# UNITED STATES PATENT AND TRADEMARK OFFICE

## Office Action Summary

10/549,394

## **DETAILED ACTION**

# EXAMINER'S ATTACHMENT A

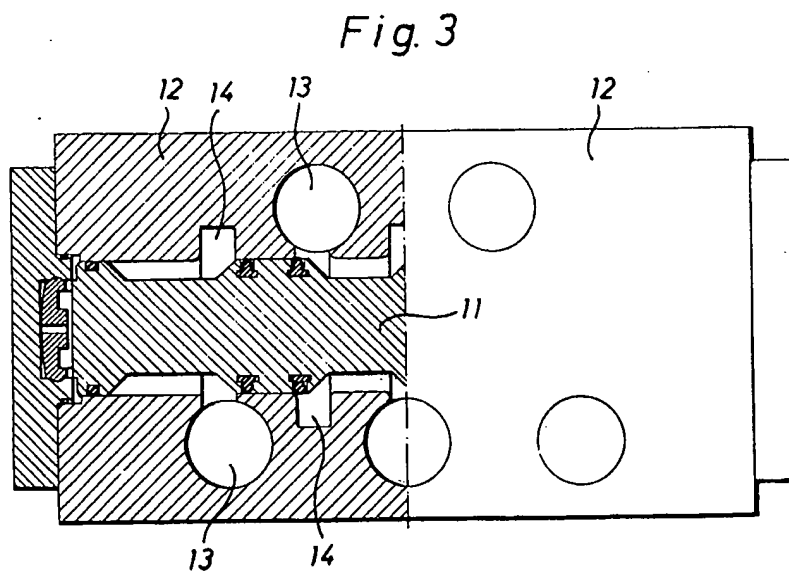
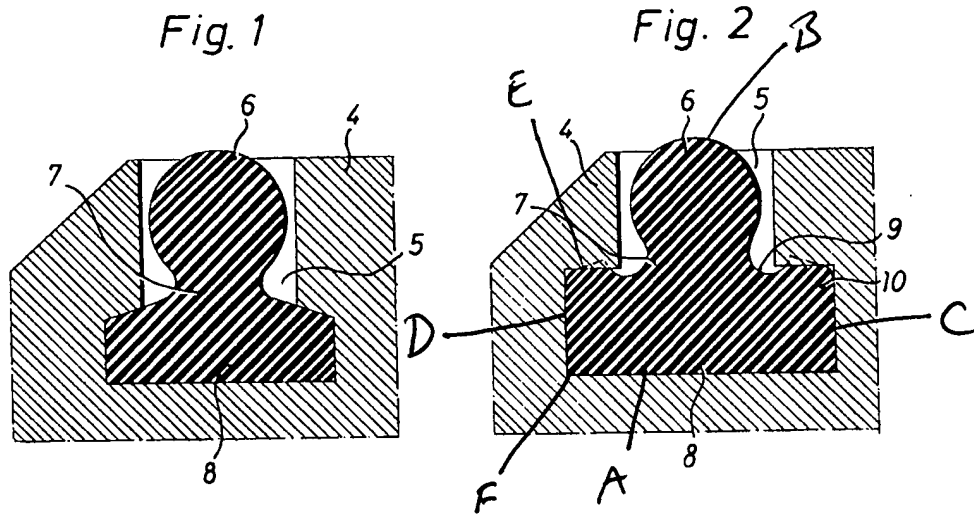
Regarding claim 1, the Engstrom reference discloses a sealing material (Col. 2, Line 8) for an ant groove (5), which is fitted to the ant groove made in a surface of either one of members in a joint place (11, 12) between these members and contacts with a surface of the other member (Fig. 3), thereby sealing both the members, with the sealing material comprising:

a sectional shape (Fig. 2) having a straight bottom edge (A) which is disposed on a bottom face of said ant groove (Fig. 2); an arched convex edge (B) which contacts

with the surface of said other member facing said ant groove (Fig. 3); a first projecting edge (C) which connects with one end of said bottom edge and projects outside (Fig. 2); a concave inlet portion (9) which is located between said first projecting edge and said arched convex edge (Fig. 2); a second projecting edge (D) which connects with the other end of said straight bottom edge and is composed of straight lines that project outside (Fig. 2); a straight sloping edge (E) of which one end connects with the opposite end of said arched convex edge as to said first projecting edge and of which the other end connects with said second projecting edge (Fig. 2); and at least one corner portion (F) which is constituted in the range of from said straight bottom edge via said second projecting edge to said sloping edge (Fig. 2). Note that the English equivalents to the patents described in the specification recite that the groove is an annular groove and has been treated as such for the examination of this application. Also note that the straight slope is connected to the arched convex edge through a concave portion (Fig. 2).

EXAMINER'S ATTACHMENT B

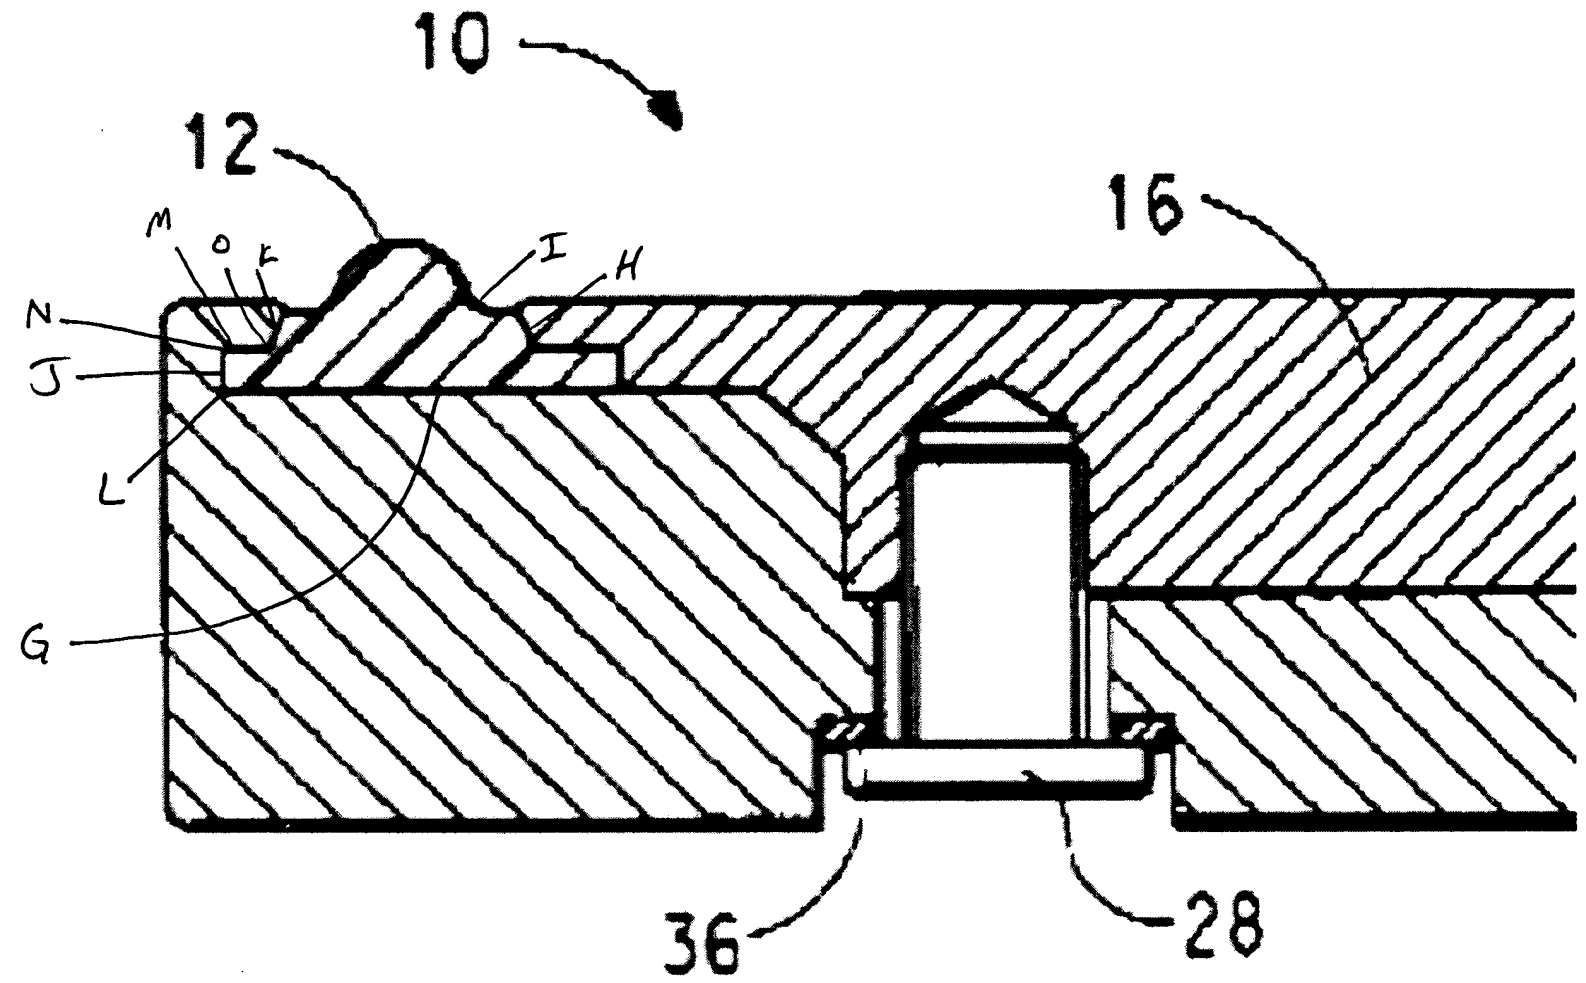
a sectional shape (Fig. 3) having a straight bottom edge (G) which is disposed on a bottom face of said ant groove (Fig. 3); an arched convex edge (12) which contacts with the surface of said other member facing said ant groove (Fig. 3); a first projecting edge (H) which connects with one end of said bottom edge and projects outside (Fig. 3); a concave inlet portion (I) which is located between said first projecting edge and said arched convex edge (Fig. 3); a second projecting edge (e.g. J and M) which connects with the other end of said straight bottom edge and is composed of straight lines that project outside (Fig. 3); a straight sloping edge (K) of which one end connects with the opposite end of said arched convex edge as to said first projecting edge and of which the other end connects with said second projecting edge (Fig. 3); and at least one corner portion (e.g. L) which is constituted in the range of from said straight bottom edge via said second projecting edge to said sloping edge (Fig. 3). Note that the English equivalents to the patents described in the specification recite that the groove is an annular groove and has been treated as such for the examination of this application. Also note that the straight slope is connected to the arched convex edge through a concave portion and horizontal edge (Fig. 3).

Regarding claim 3, the Kane et al. reference discloses said second projecting edge being formed by connecting a pair of straight edges (J and M) together in a triangular shape; and

said corner portion being constituted in the following three places: a place between said straight bottom edge and said second projecting edge (L); a crooked place of said second projecting edge (N); and a place between said second projecting edge and said sloping edge (O).
